Dennis-
Another few items

Drive-Up Charging Stations

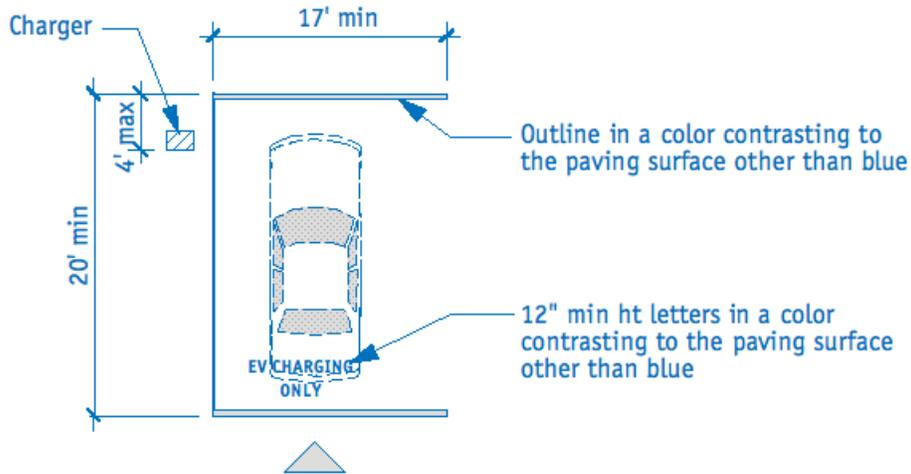
Confusion for Drive-up spaces. The space requires to be 17' wide and does not require markings to define the width nor any access aisle. Does this mean that I need a line at the head and foot of the pull-up space demarcating the 20' length? If it does, this marking extends for a 17' distance? This could be strange sticking out into what might be a passing drive aisle. Does this mean that if I had 2 side by side charging stations can this 17' wide space overlap for each - if so how much?

Below is a sketch from what I am reading from the code - is this the intent and the location for the charger? The striping? The identification painted on the ground?
